State of New Mexico
Energy, Minerals and Natural Resources

SUNDRY NOTICES AND REPORTS ON WELLS
(DO NOT USE THIS FORM FOR PROPOSALS TO DRILL OR TO DEEPEN OR PLUG BACK TO A DIFFERENT RESERVOIR. USE "APPLICATION FOR PERMIT" (FORM C-101) FOR SUCH PROPOSALS.)
1. Type of Well: Oil Well [x] Gas Well [] Other []
2. Name of Operator: EOG Resources, Inc.
3. Address of Operator: 104 South Fourth Street, Artesia, NM 88210
4. Well Location: Unit Letter B : 660 feet from the North line and 1980 feet from the East line. Section 1 Township 20S Range 24E NMPM Eddy County
11. Elevation (Show whether DR, RKB, RT, GR, etc.): 3592'GR

NOTICE OF INTENTION TO:
PERFORM REMEDIAL WORK [] PLUG AND ABANDON [x]
TEMPORARILY ABANDON [] CHANGE PLANS []
PULL OR ALTER CASING [] MULTIPLE COMPL []
DOWNHOLE COMMINGLE []
CLOSED-LOOP SYSTEM []
OTHER: []
SUBSEQUENT REPORT OF:
REMEDIAL WORK [] ALTERING CASING []
COMMENCE DRILLING OPNS. [] P AND A []
CASING/CEMENT JOB []
OTHER: []
Notify OCD 24 hrs. prior to any work done

EOG Resources, Inc. plans to plug and abandon this well as follows:

Foster AN 2 Proposed

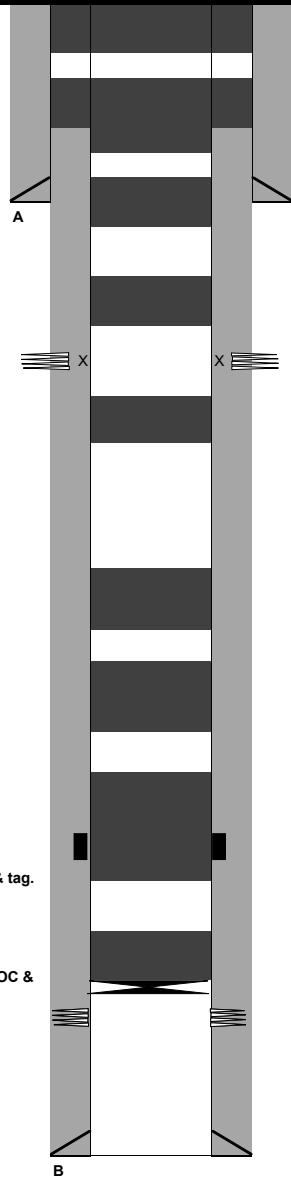
2/17/2018 CBL 2800' to Surface - No log in file

4. Spot a 26 sx Class "C" cement plug from 5233'-5078'. This will cover Abo top. Perf & attempt injection - WOC & tag
5. Spot a 25 sx Class "C" cement plug from 3444'-3295'. This will cover Bone Spring top. Perf & attempt injection - WOC & tag

6. Spot a 25 sx Class "C" cement plug from 2232'-2083'. This will cover Glorieta top. Perf & attempt injection - WOC & tag
7. Perforate at 1136'. Attempt injection rate. Spot a 25 sx Class "C" cement plug from 1136'-987'. WOC and tag. This will cover surface casing shoe.

10. Cut off wellhead and install dry hole marker. Clean location as per regulated. Perf @ 200' & attempt to Circ to surface

Plug 8 - Perf @ 100. 0-100. Verify @ Surface. Surface plug

Plug 7 - Perf @ 640. 520-729. WOC & tag. TOC & San Andres
Calc TOC at 679'

Plug 6 - Perf @ 1136. 987-1136. WOC & tag. Sur. Csg. Shoe

Plug 5 - 2083-2232. Glorieta Top

Plug 4 - 3295-3444. Bone Spring Top

Plug 3 - 5078-5233. Abo Top

Plug 2 - Perf @ 5743. 5476-5843. WOC & tag. DV Tool & Wolfcamp Top

Plug 1 - CIBP @ 7630. Pressure test. WOC & tag. Canyon Perfs + Canyon top
Existing Canyon Perfs: 7,680' - 7,790'
